Agenda
Hailey Planning and Zoning Commission
Monday, May 19, 2025
5:45 p.m.

FINDINGS OF FACT, CONCLUSIONS OF LAW AND DECISION

Staff Report
Hailey Planning and Zoning Commission
Regular Meeting of May 19, 2025

DOWNTOWN MASTER PLAN
 PHASE 1 IMPLEMENTATION

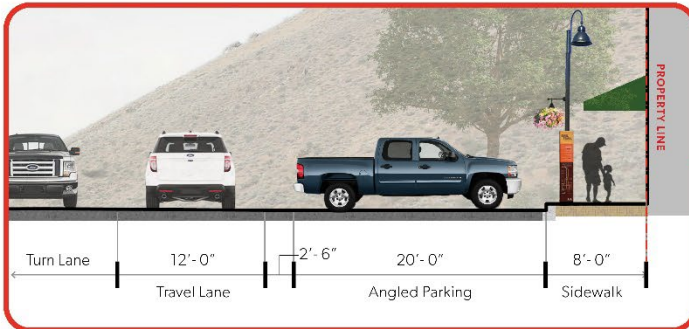
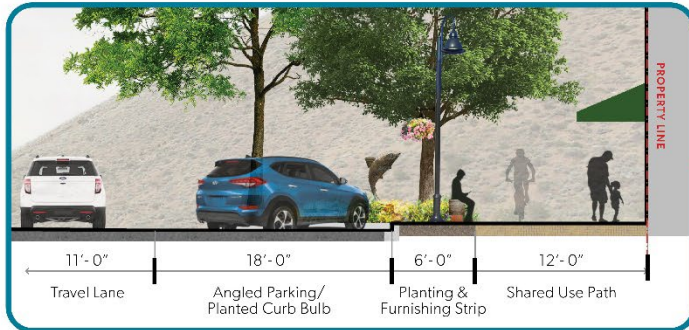
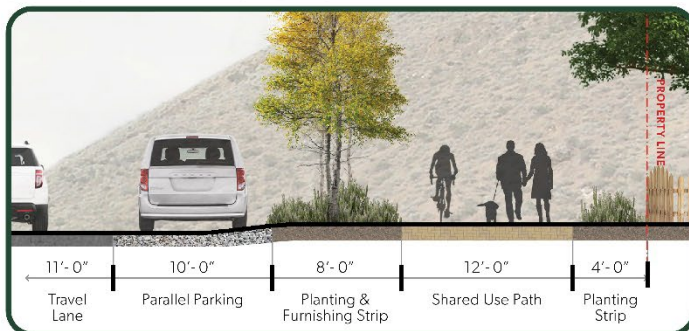
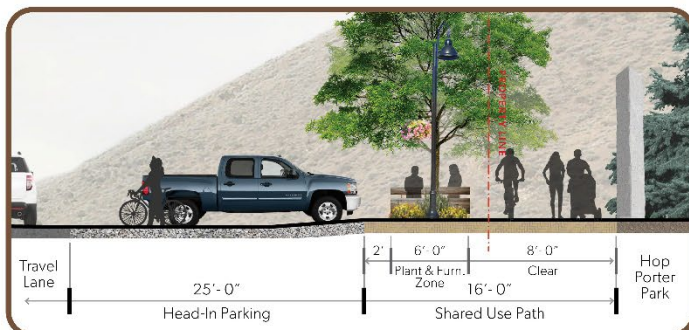
However, four (4) of the five (5) Commissioners expressed acute concern with a small but significant portion of the proposed Pathway design. “Downtown Section 01”, as depicted in [the presentation materials \(see here\)](#) provided by consultant GGLO to City Staff, is located at the corner of W Bullion and Main Street/SH75, on the north side of W Bullion. This section represents the eastern start/end point of the overall Bullion Street Pathway Design proposal.

Regarding the proposed loss of three (3) parking spaces, business owners and some members of the public expressed strong pushback during engagement sessions. One (1) member of the Planning and Zoning Commission attended a recent public workshop and site visit, and they shared their observations from the visit at the May 5, 2025, Public Hearing. Strong business owner sentiment for preserving all existing parking spots with any future development of the Bullion Pathway was expressed, according to the Commissioner who attended. At the May 5, 2025, Public Hearing, all members of the Commission engaged in robust discussion around the need for improved user safety at the corner location, as well as supporting local businesses and a vibrant downtown economy, which accessible, convenient parking helps to facilitate. Present realities and constraints, public feedback, and desired future conditions were all elements to the Commission’s conversation, demonstrating balance and thoughtful consideration amongst the recommending body.

Extensive public comment has been solicited in the form of public meetings and specific work sessions for adjacent residential and commercial businesses. On some topics, such as parking, a variety of viewpoints exist. A compromise design for the first half-block between Main Street and the alley retains the current existing five (5) angle-in parking spaces.

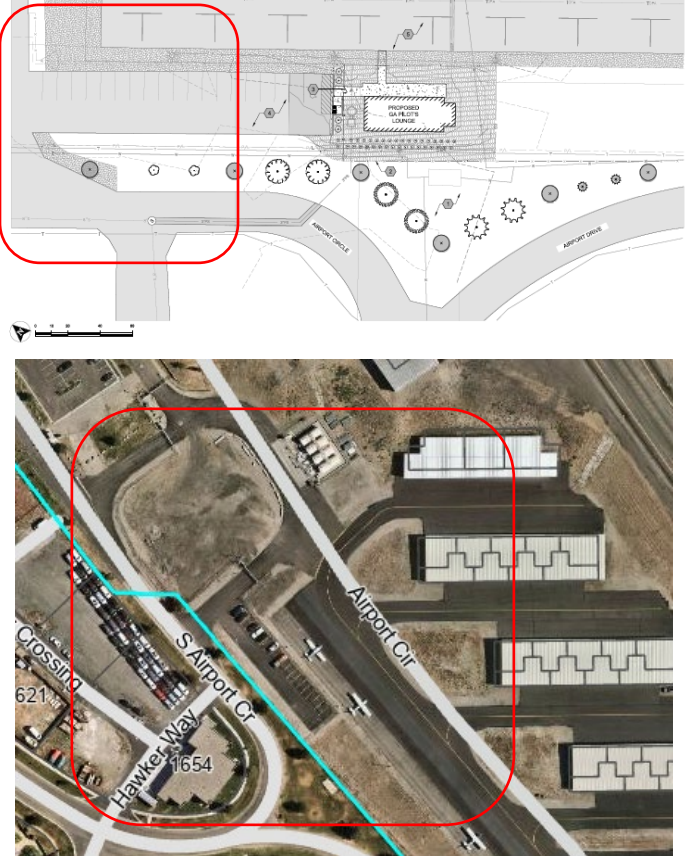
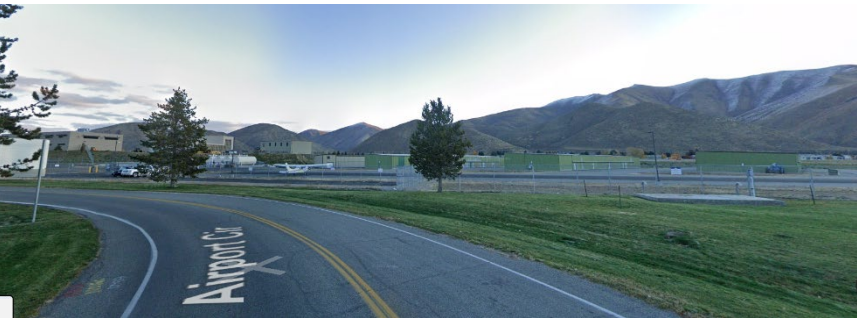
<input checked="" type="checkbox"/>	<input type="checkbox"/>	<input type="checkbox"/>	17.11.040.01(g)	g. Will have vehicular approaches to the property which shall be designed so as not to create an interference with traffic on surrounding public thoroughfares;
			<i>Staff Comments</i>	<i>While this CUP Application does not require onsite access, the proposed site access for the associated Pilot's Lounge is from a single ingress/egress located at the north end of the exiting parking area and connected to South Airport Circle, as shown below.</i>

<p><i>Findings: Compliance. This standard is either not applicable or has been met.</i></p>
<input checked="" type="checkbox"/>	<input type="checkbox"/>	<input type="checkbox"/>	<p>17.11.040.01(h)</p> <p>h. Will not result in the destruction, loss or damage of a natural, scenic or historic feature.</p> <p><i>Staff Comments</i></p>	<p><i>No trees or mature landscaping, scenic or historic features will be removed from the site to accommodate for the proposed use. All existing trees and lawn will be retained.</i></p> <p><i>Findings: Compliance. This standard is either not applicable or has been met.</i></p>

Amended plans:

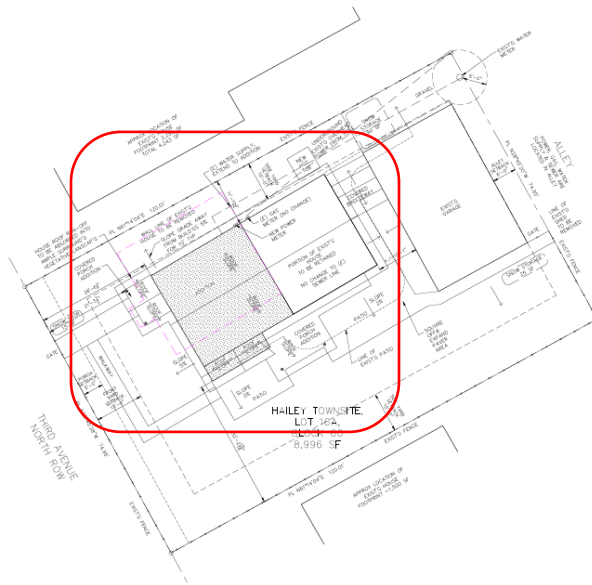
- The single-family addition is reduced by approximately 20% in size, due to 13' of the E/W length of the addition being removed. The originally approved addition of 1,087 square feet has been reduced to 734 square feet. The exterior building materials, house shape, location, height and exterior lighting remain the same as originally approved.

- The originally proposed and approved ADU was eliminated via a Design Review Modification of the garage at time of building permit submittal.
- The exterior color has also been amended. The proposed addition was formerly a light gray paint color for the board and batten siding on the garage. The Owners are proposing to match the dusty blue color on the existing house: The board and batten on the house will be painted to match the approved dark blue of the garage siding, which will match the existing blue siding on the ground floor rear of the house.
